SCF Purchasing Department
7033 East Tudor Road
Anchorage, AK 99507

RE: Addendum No. 3
RFP SCF25-1179
McGrath K-House Structural Improvements
Revised scope of work

ONE INCH		ONE INCH	
10/29/2025 1:56:21 PM		10/29/25	
250 H Street Anchorage, AK 99501 P: (907) 243-8985 F: (907) 243-5629 W: LCGAK.com		BY DATE NO REVISION	
ICG Lantech Inc architecture • engineering • surveying		ADDITION 1	
SOUTH CENTRAL FOUNDATION		1	
SECTIONS		4	
MCGRATH K HOUSE REPAIR PLANS MCGRATH, ALASKA		S3	
P:\1250-1299\1285.09 McGrath K Street House Renovation\Architecture\1285.09 McGrath K House Repairs - S.rvt		SHEET NUMBER	
SHEET SIZE: 34x22		OF 4	
DESIGNED BY: DM		DATE: 6/23/2025	
DRAWN BY: SC		FILE NO. 1285.09	
CHECKED BY: DM		SHEET NUMBER	
DATE: 6/23/2025		S3	
FILE NO. 1285.09		OF 4

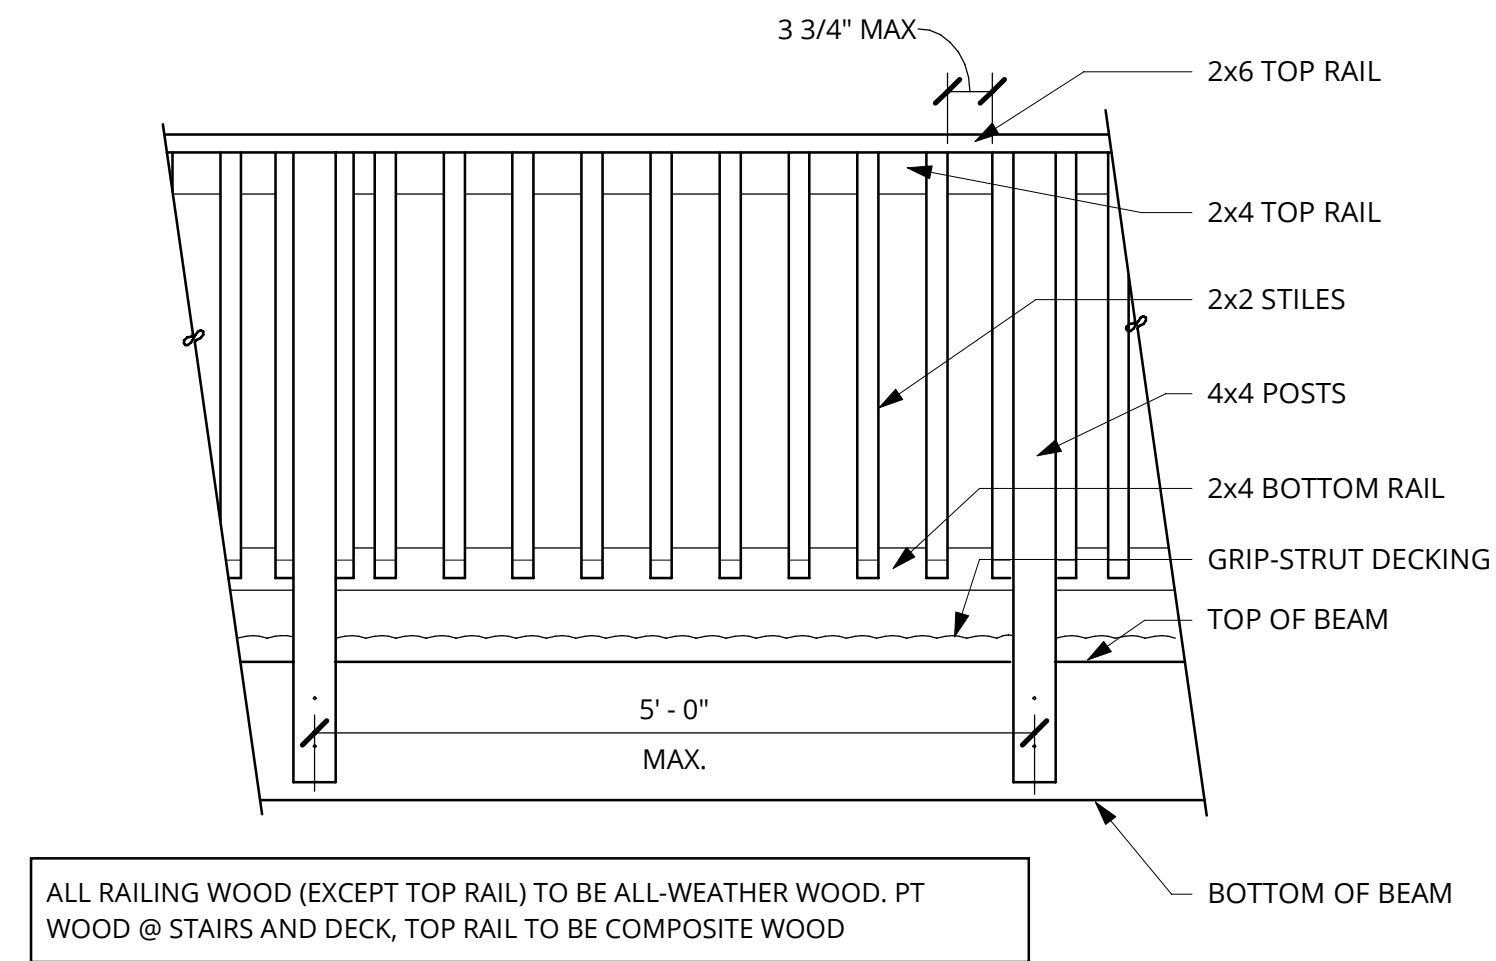
Additionally, I'm providing specifications for a new 500 gal fuel tank that is called out in the supplemental design drawings.

Additional scope.

Contractor will salvage existing house metal roof sheeting and install it on the sides of the shed.

A 500 gallon above ground fuel tank

- Double wall.
- UL-142 and STI F-921 secondary containment listed.
- All required openings
- Primary and secondary emergency vents
- Atmospheric combo whistle vent
- Exterior sandblasted and coated with white polyurethane.
- All required placards
- Top Fill Package
- Ladder, Overspill containment can, daybreak adapter, fill limiter w/drop tube, FOS drop tube w/foot valve, clock gauge, and mechanical leak gauge.

1 SECTION THRU PORCH

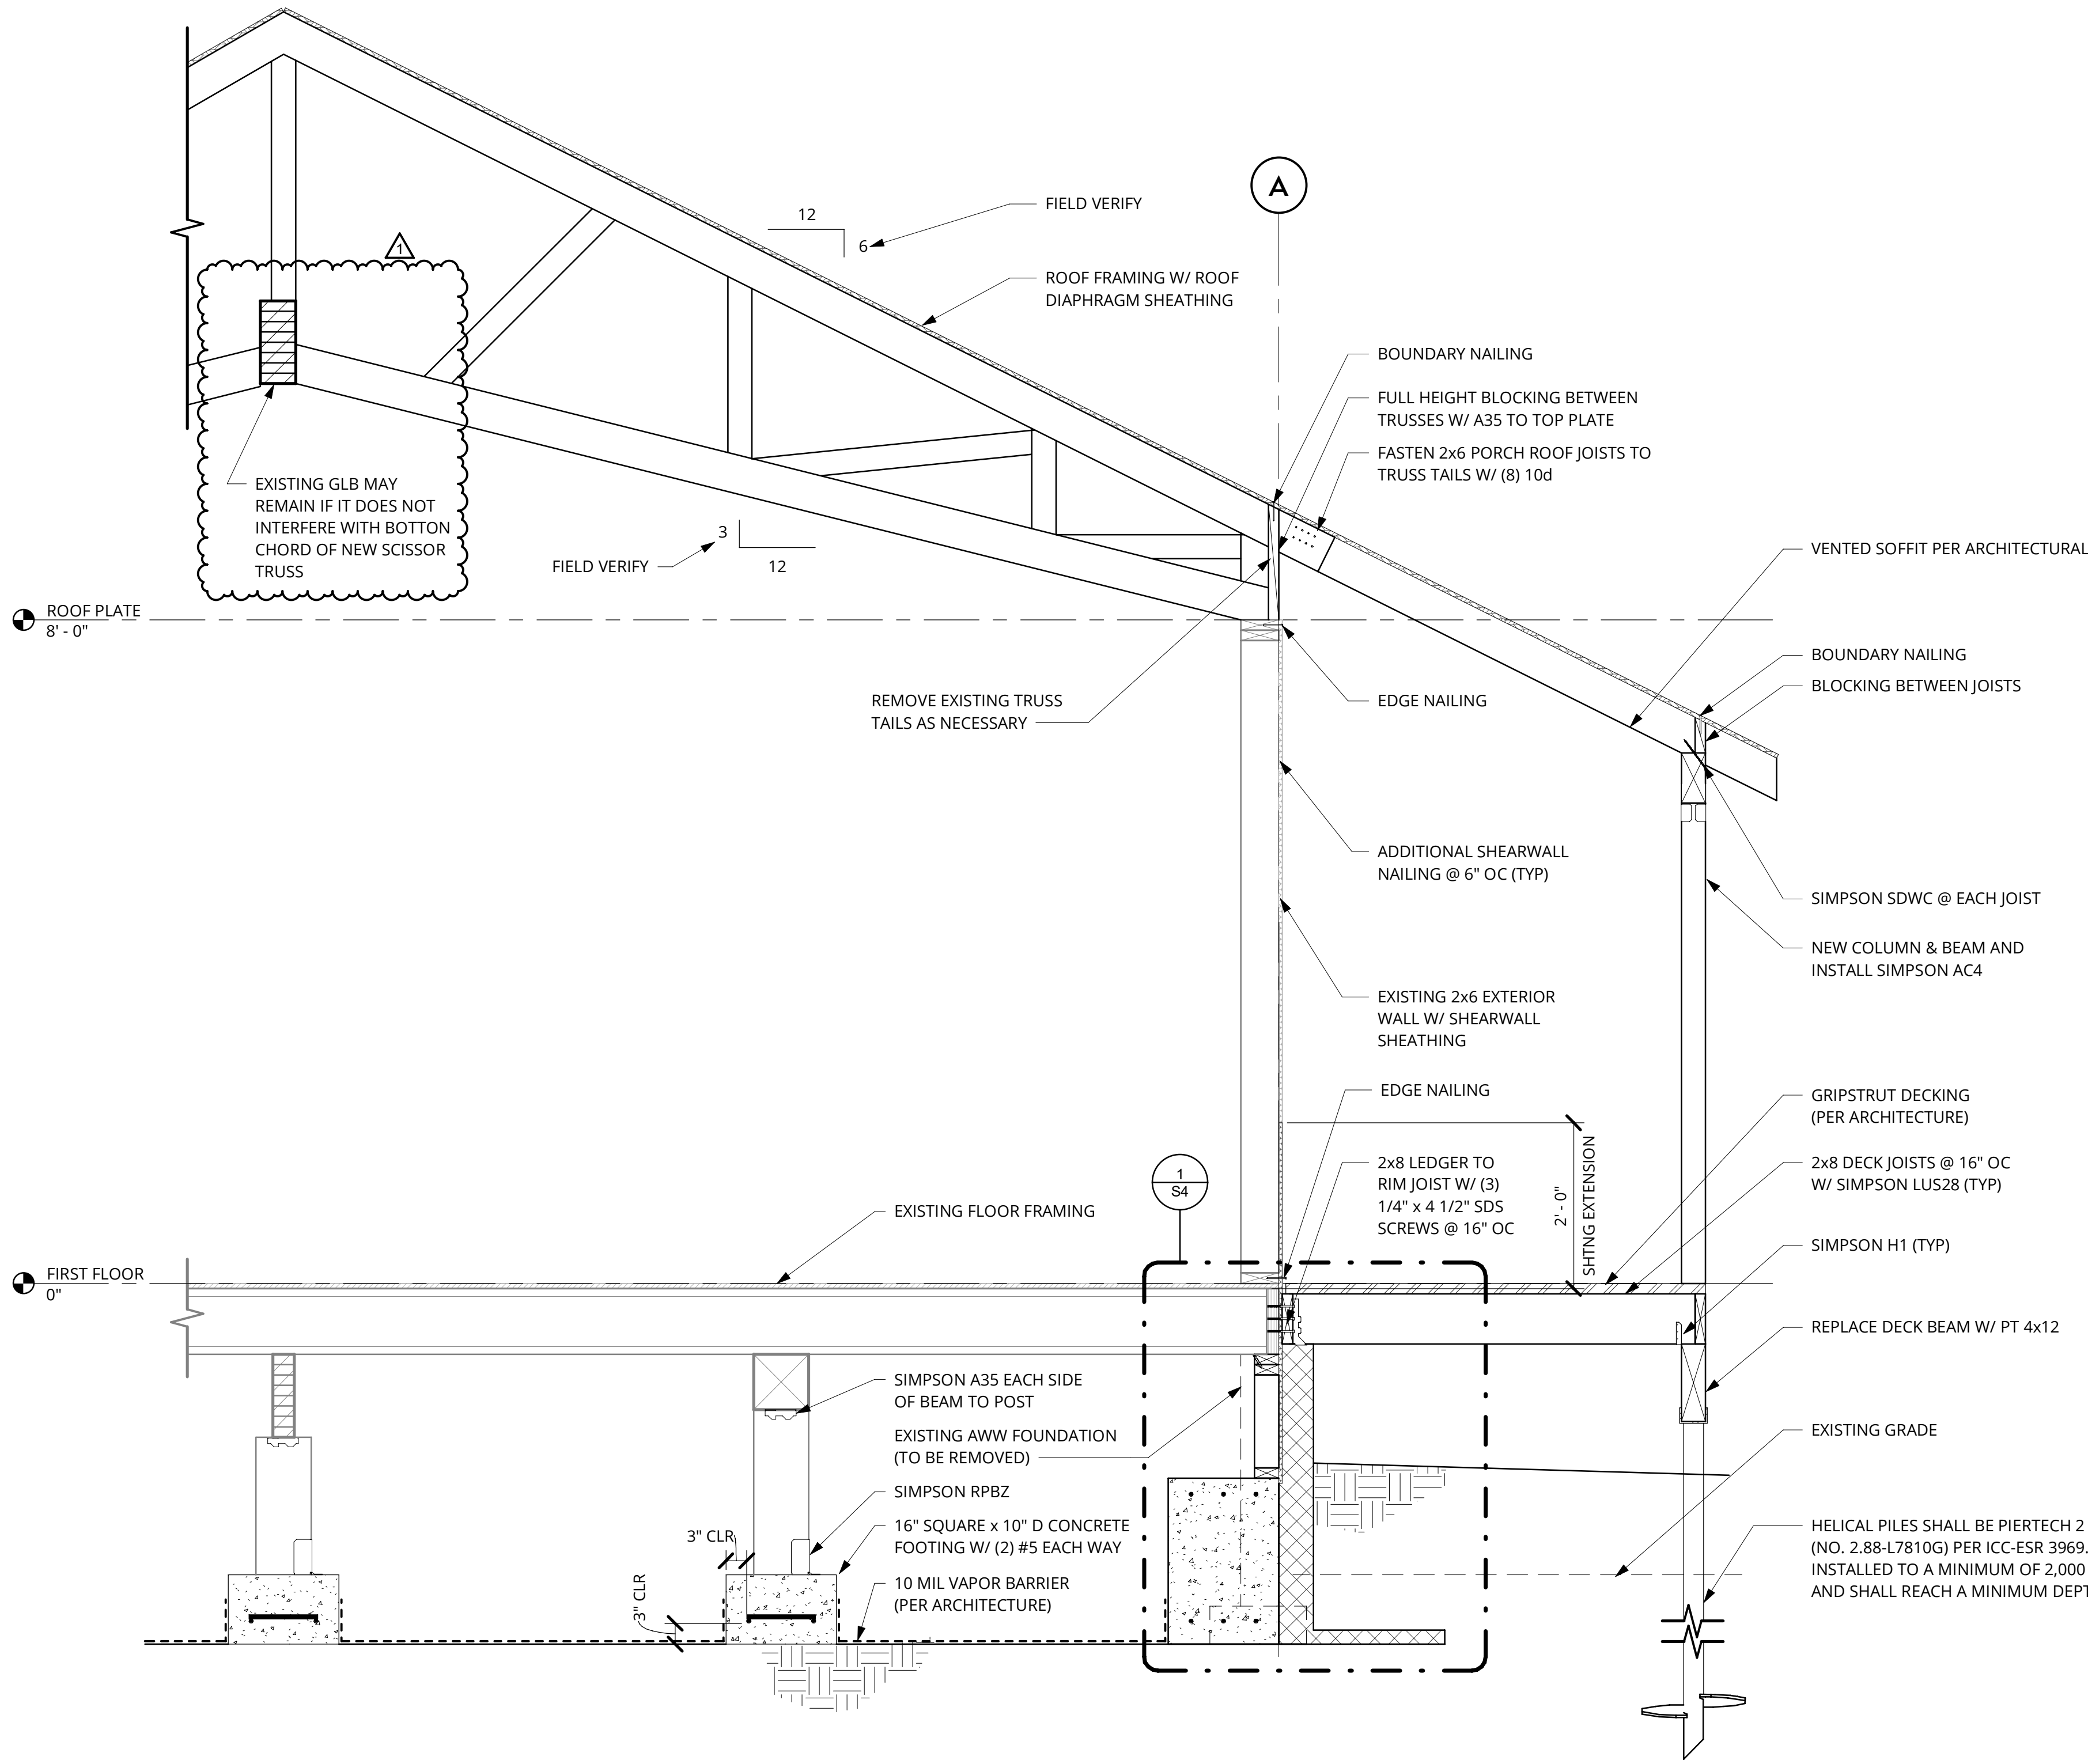
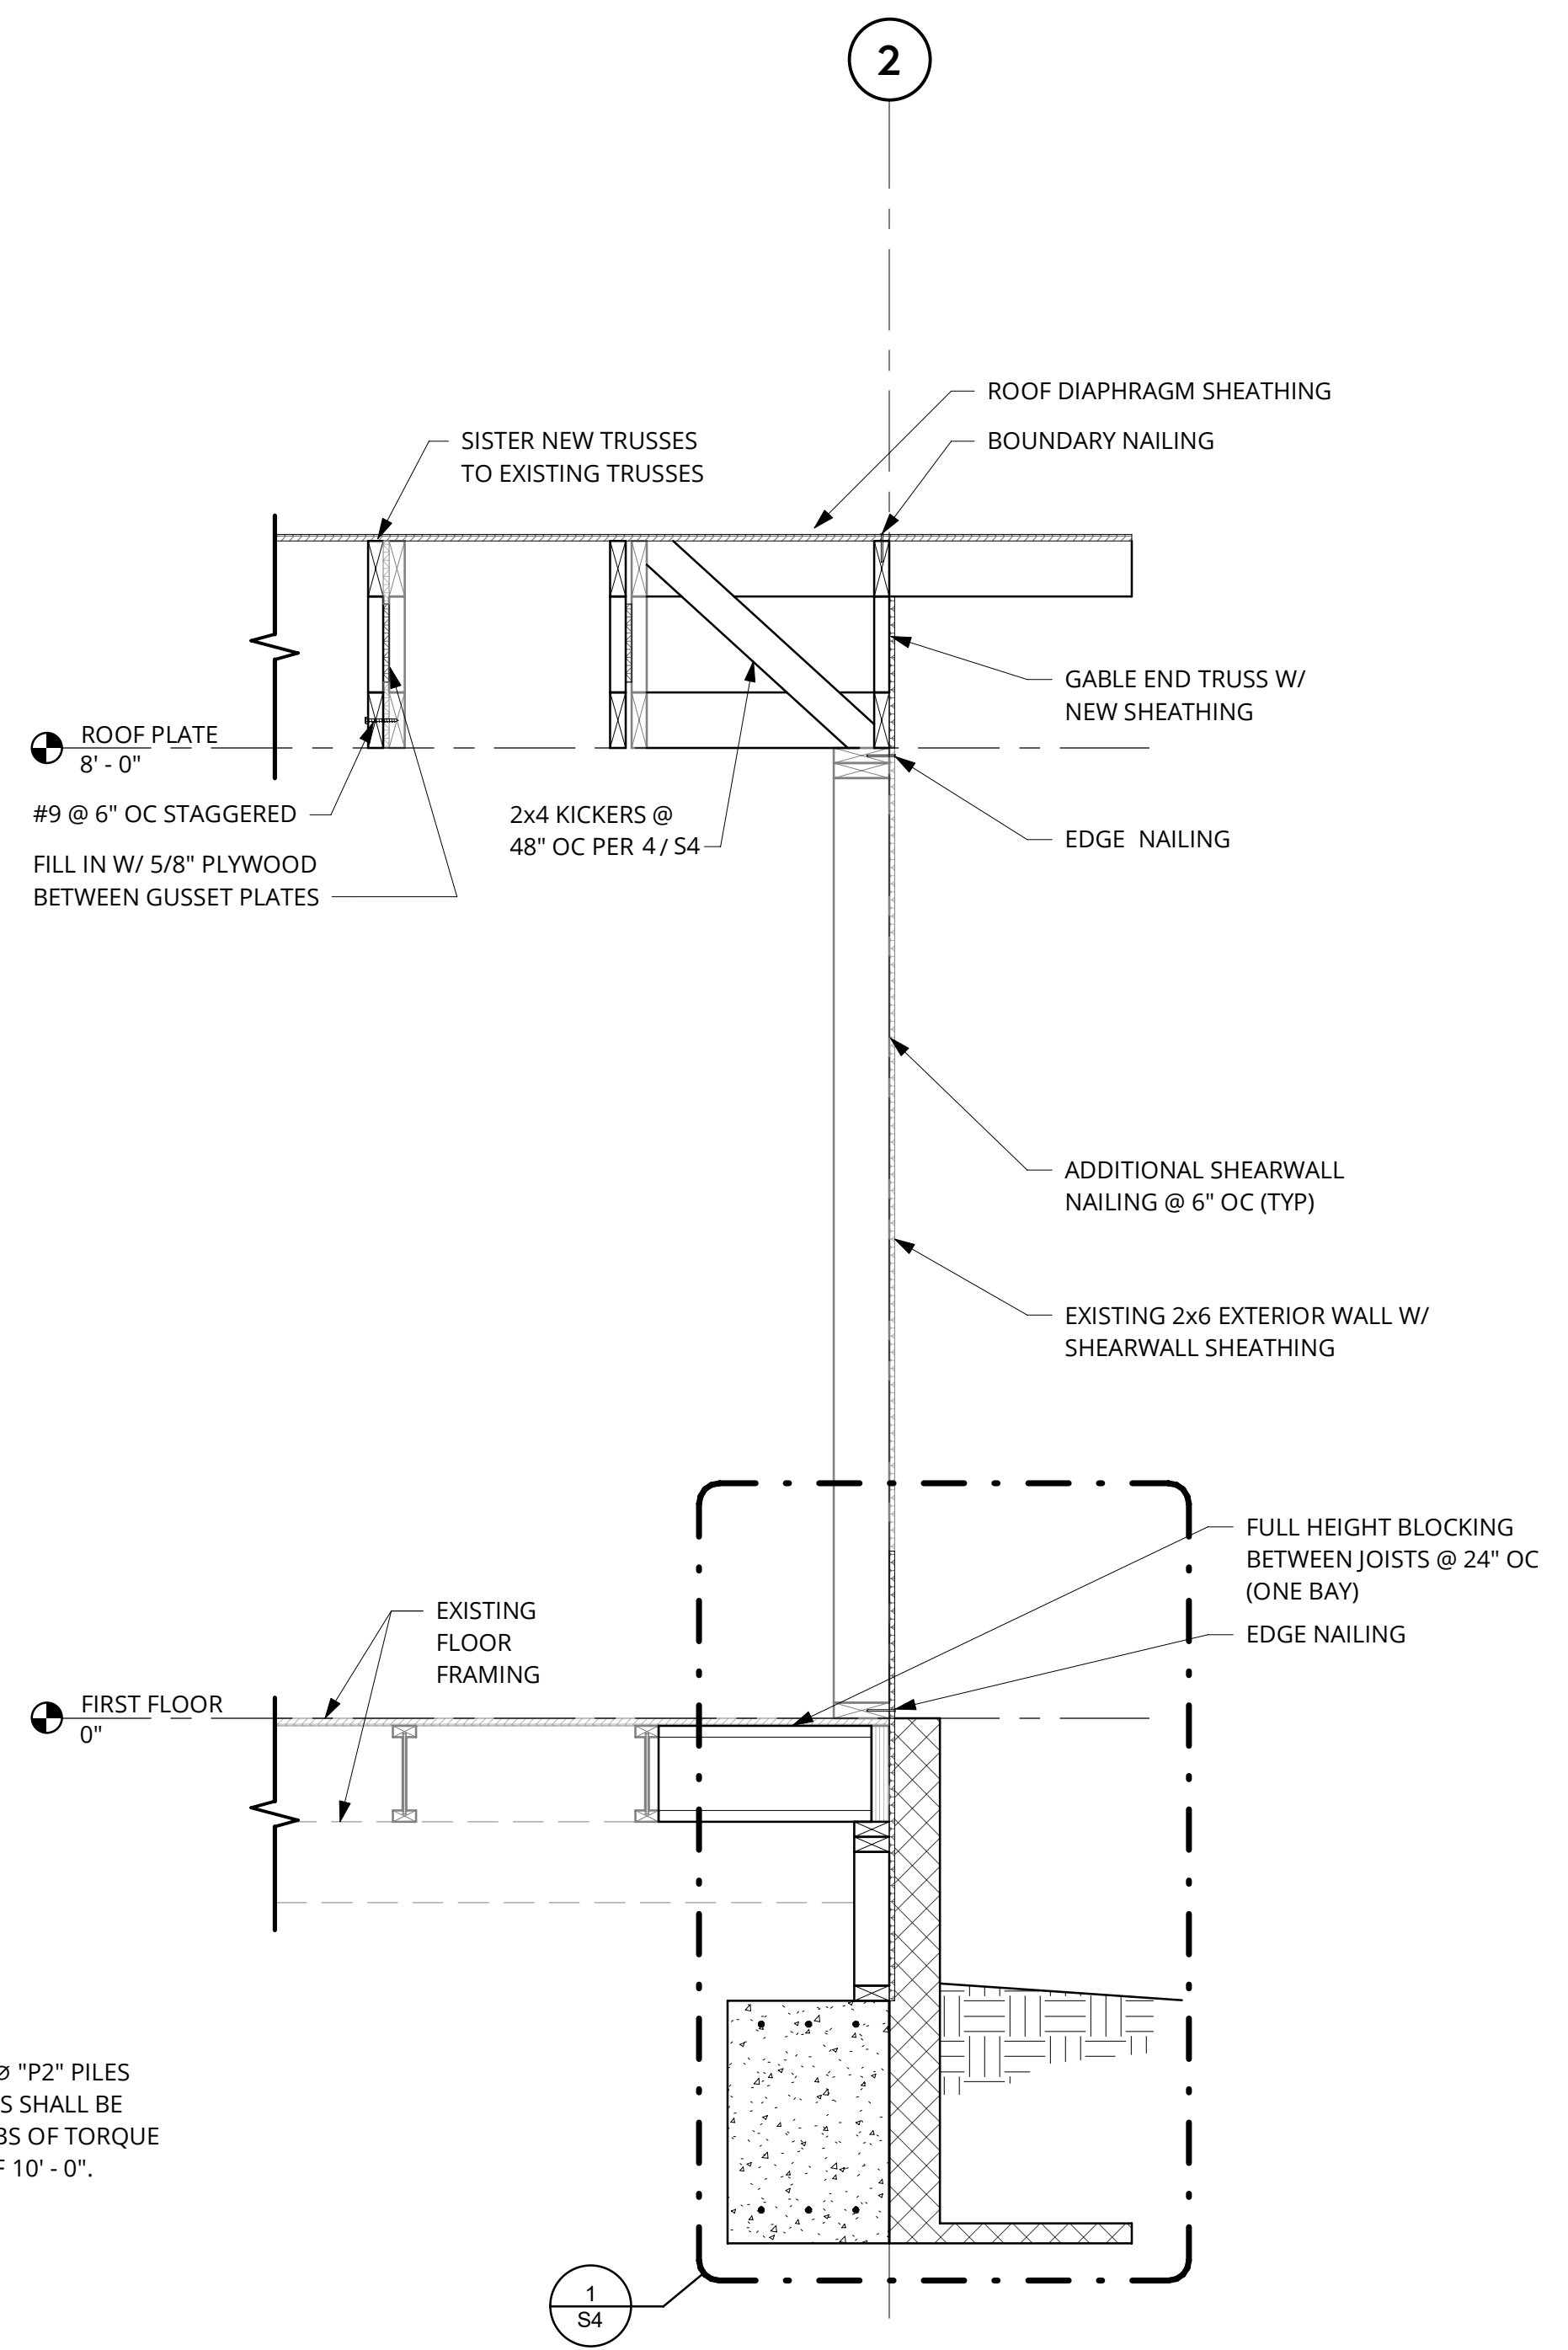
Clouded elements on design drawings signify changes; corresponding on-sheet spec and table notes and fuel tank specs provide additional information.
